I am responding to your 28 June 1976 letter concerning the Citrus Lakefront Levee--IHMC to Paris Road project, which is a feature of the Lake Pontchartrain Hurricane Protection project.

RE: NEW ORLEANS, LOUISIANA - Proposed reconstruction of Citrus Lakefront Levee -  
Paris Road to IHNC.

CITRUS LAKEFRONT LEVEE

# CITRUS LAKEFRONT LEVEE

STA. 123+00

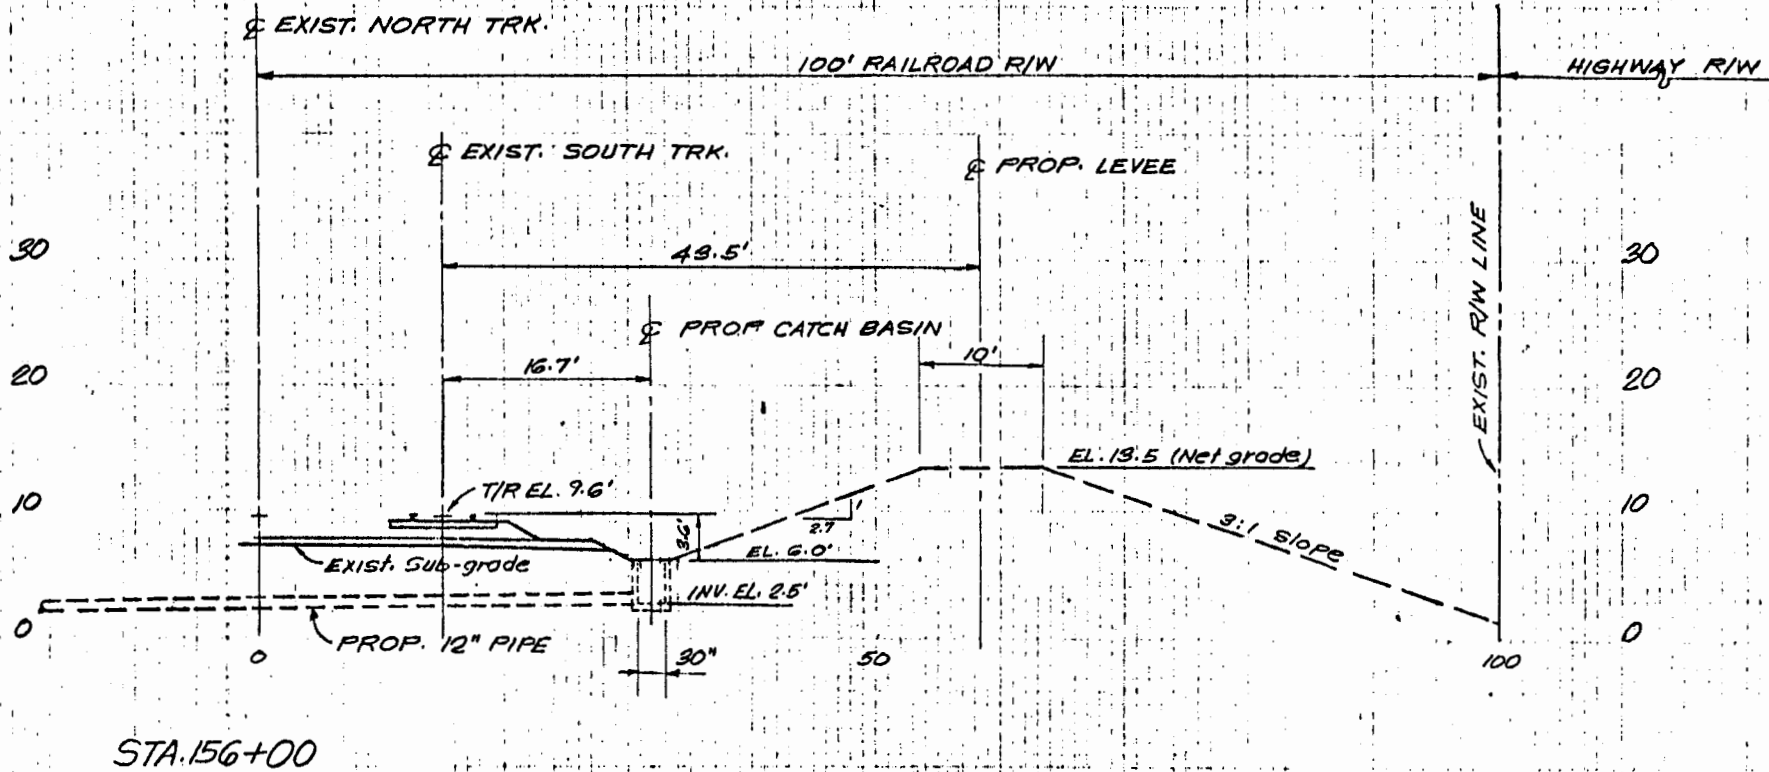
I note you did not agree with my recommendation to reducing width of some catch basins from 4 feet to 30 inches at locations where there is insufficient ditch width to accommodate a 4' wide catch basin without recessing it into the proposed toe of the new Levee. I am again furnishing you with copy of cross-sections I plotted for Stations 123 and 156 which show catch basins to be

The catch basins were designed to be 4 feet wide, clear opening, for maintenance purposes. A basin narrower than 4 feet would not provide sufficient room for a normal size person to stand in the catch basin and clean out the basin and/or the culvert. The maintenance of the catch basins is already restricted because of the depth of the catch basins (3 feet to 3.5 feet). This depth was set by your criteria of providing at least 5.0 feet of vertical clearance below the bottom of your rail to the top of the culvert. Therefore, the 4-foot by 4-foot clear opening is necessary.

TYPICAL SECTION  
 WITH  
 20 ft CROWN AND 1V ON 3H SLOPES  
 STATIONS 28+21 to 64+00  
 LMNED - FS  
 JAN 74

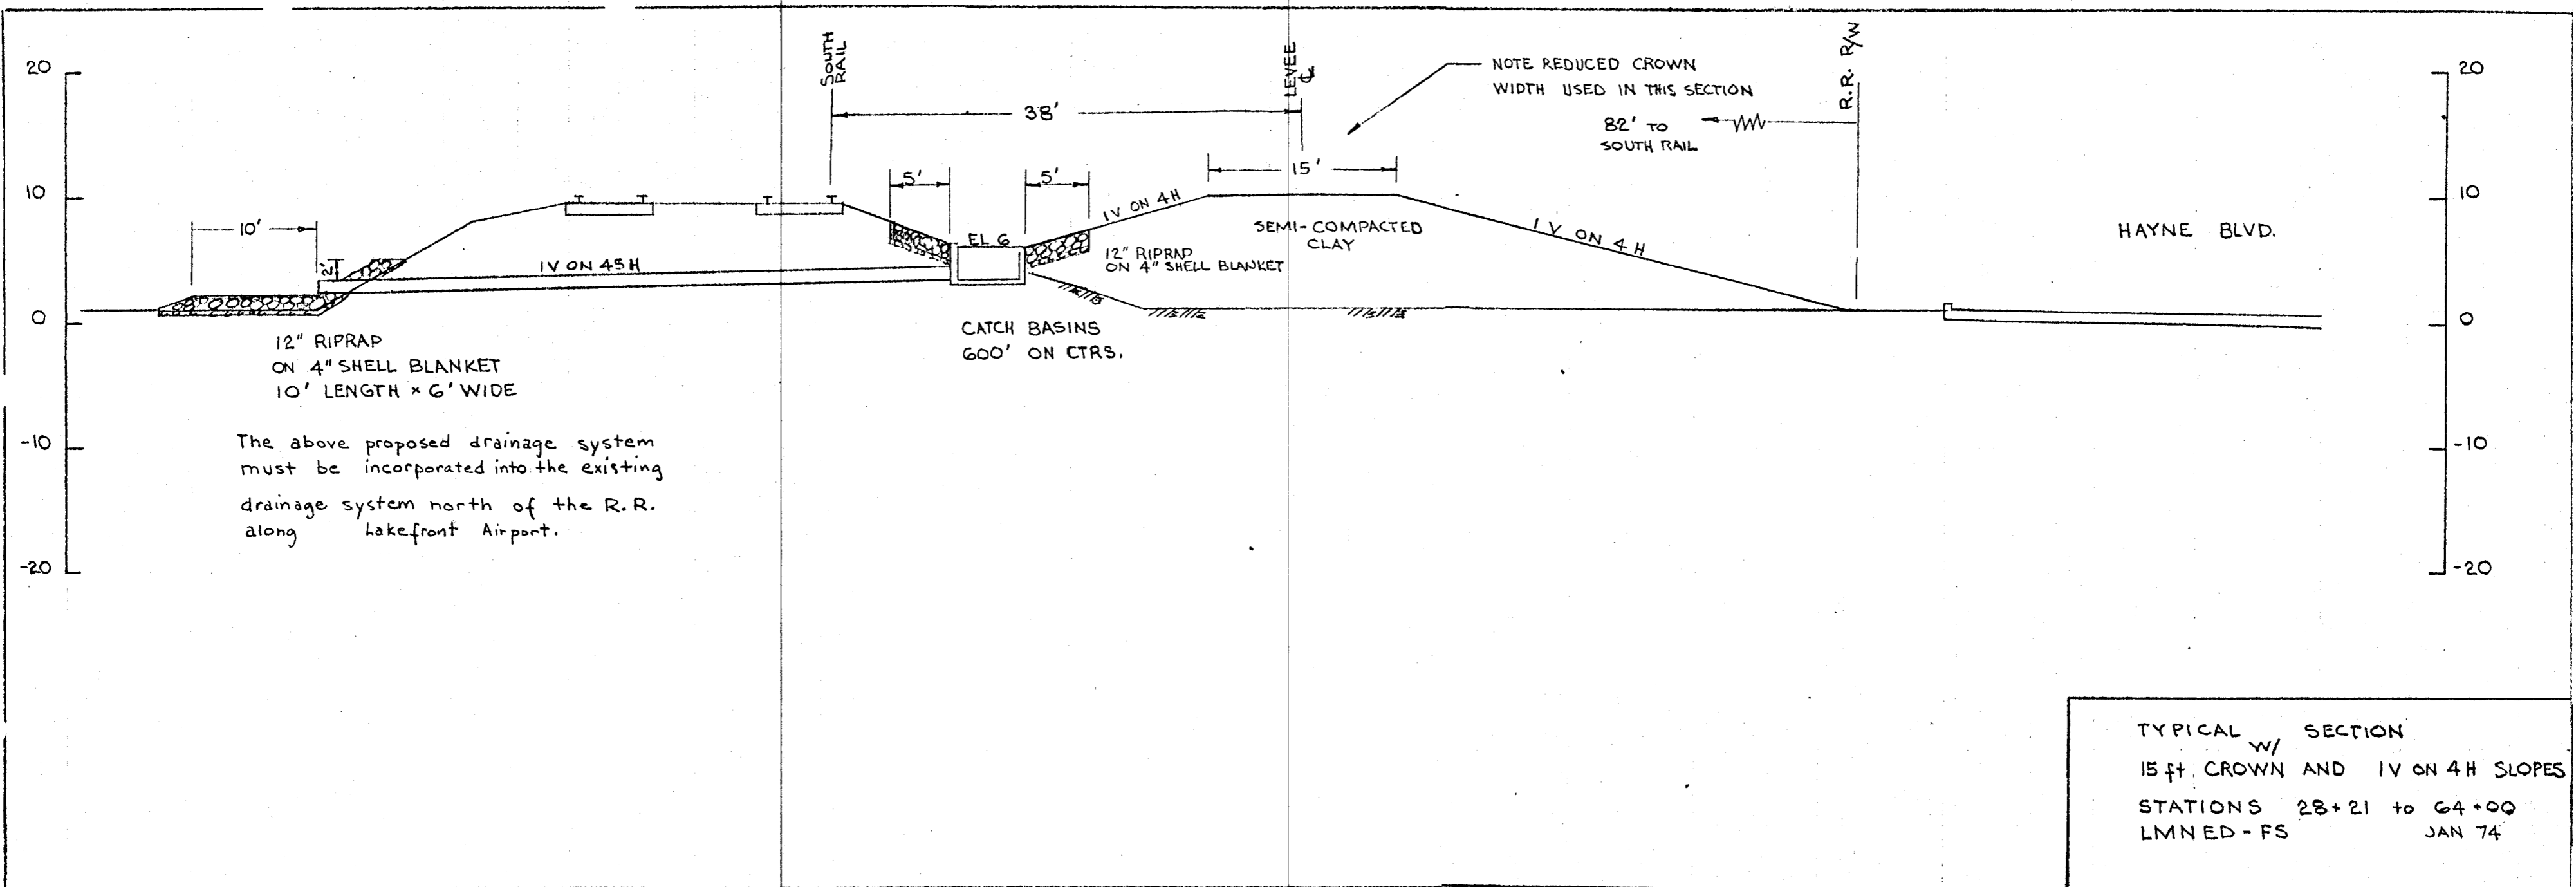
The above proposed drainage system must be incorporated into the existing drainage system north of the R.R. along Lakefront Airport.

1. In order to comply with the requirements of the Southern Railway System it was necessary to change the levee design between Stations 28+21 to 64+00 to that shown on attached inclosure 1.

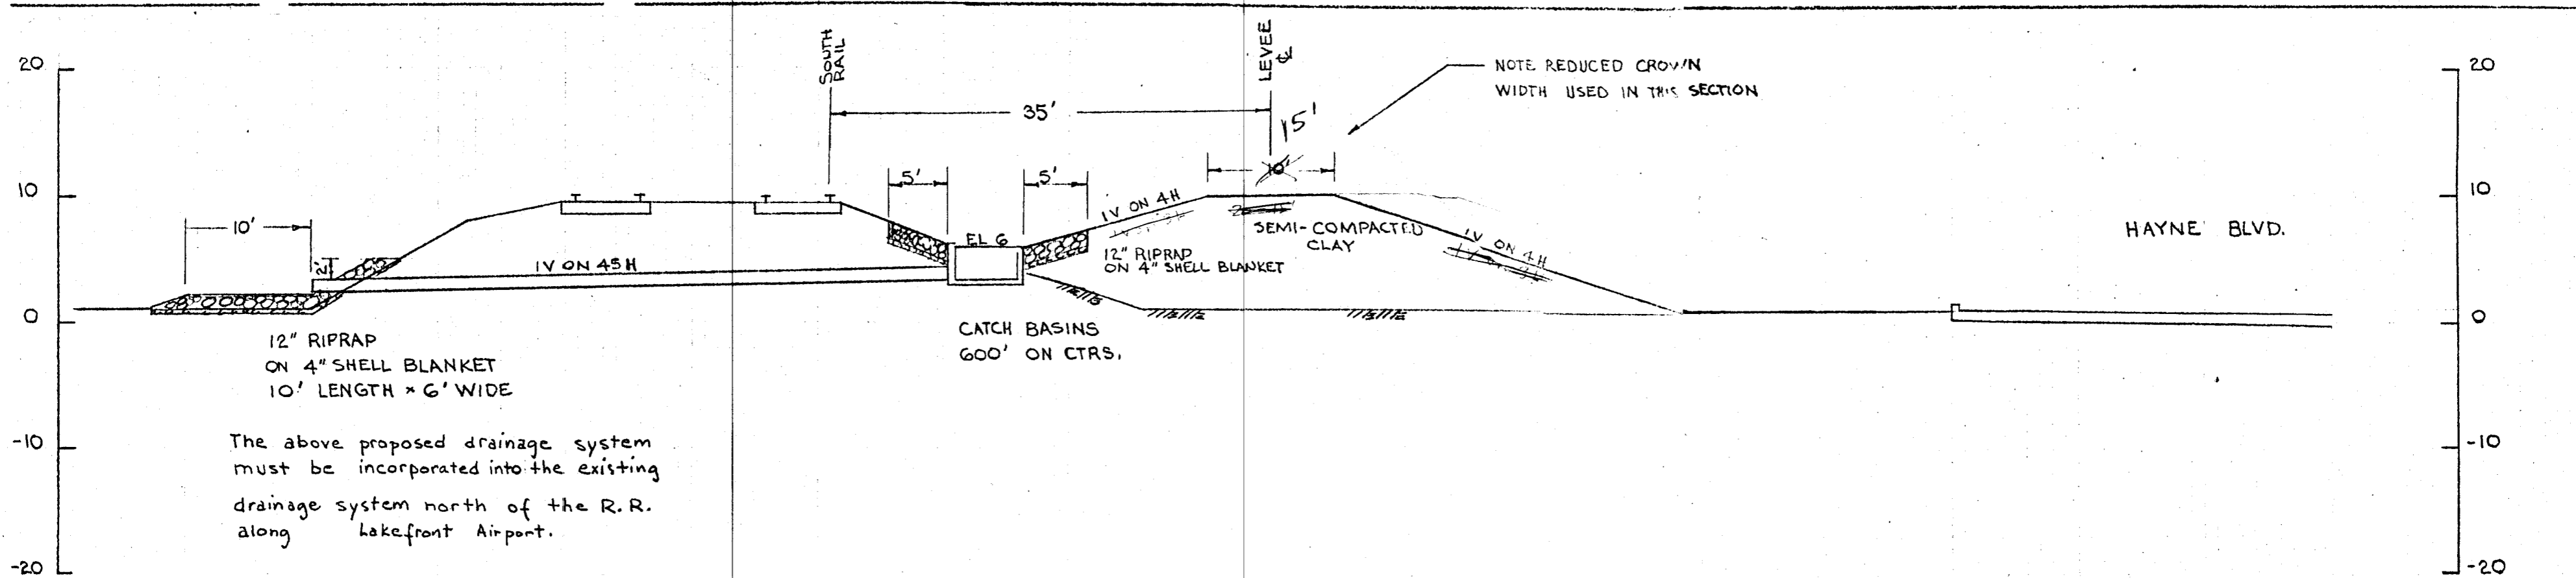
1. Reference is made to the letter from Mr. H. Mauney, Southern Railway System, inclosure 2.
2. The railroad was previously furnished inclosure 4 for their review, and their comments are based on that design.
3. Please furnish the Levees Section your comments on the railroad's request, and any recommended design sections.
4. It is suggested that the same design section as was used from station 64+00 to station 331+50 be used from station 28+21 to station 64+00 since the landside right-of-way width is constant for the limits of the job. It is recommended that the drainage between station 28+21 to station 64+00 be accomplished in the same manner as that designed for the reach from station 64+00 to station 331+50.
